**PLANNED UNIT DEVELOPMENT
& SUBDIVISION STAFF REPORT****Date: September 21, 2006****SUBDIVISION NAME**

Wimbledon Park Subdivision, Resubdivision of Lot G-8

APPLICATION NUMBER 21 & 22 DATE September 21, 2006
 APPLICANT Wimbledon Park Subdivision, Resubdivision of Lot G-8
 REQUEST Subdivision, Planned Unit Development

SITE PLAN

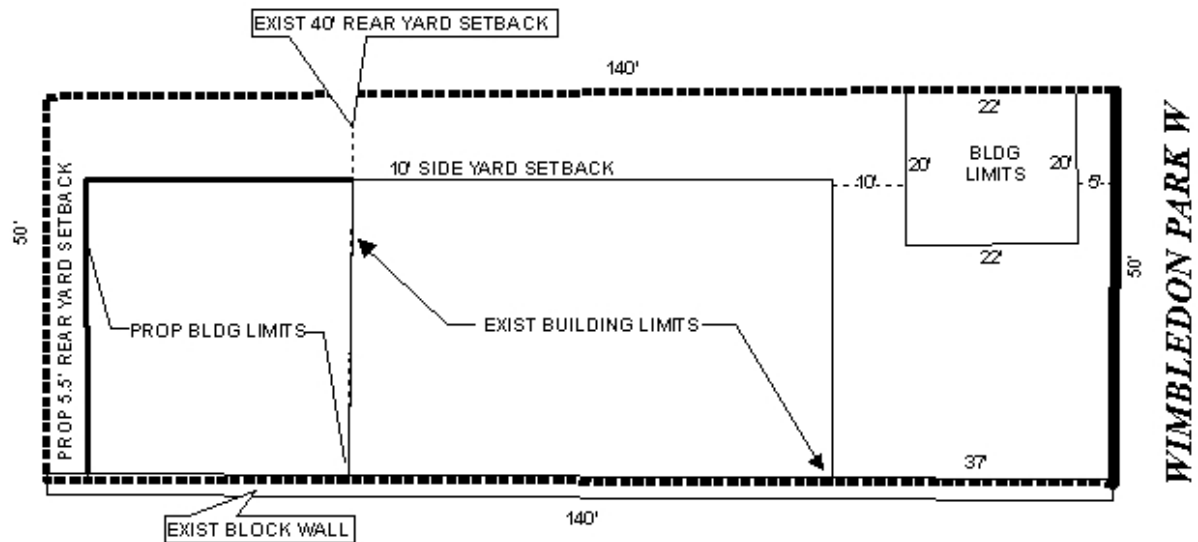
While allowing the construction of the storage shed seems fair and consistent under the circumstances, approval of the much larger building limits shown seems an excessive remedy. Expanding building limits as proposed would allow future additions within the building limit area and further increase site coverage; for other property owners to follow this example could be detrimental to the detention system. Instead, it is recommended that the building limits show a discrete area to the rear of the property where a shed would be allowed, just as the garage areas are shown on the original plats, to the front of the lots.

Site plans for the house showed a potential shed measuring 10' 10" by 12' 10", sited on the South property line and 5.5 feet from the rear property line. Allowing, for example, a 15' by 15' building limit in the rear, set back 5 feet from the rear property line, would serve the desired purpose without setting a precedent for building out these lots to such an extent. In addition, revised site plans should be to scale.

Subdivision Based on the preceding, this application is recommended for Tentative Approval, subject to the following conditions: 1) revision of the plat to add a 15' by 15' building limit at the rear of the property, rather than the fullest extent requested; and 2) submission of a revised copy of the site plan for the PUD file, prior to signing the final plat.

Planned Unit Development Based on the preceding, this application is recommended for Tentative Approval, subject to the following conditions: 1) revision of the site plan to add a 15' by 15' building limit at the rear of the property, rather than the fullest extent requested.
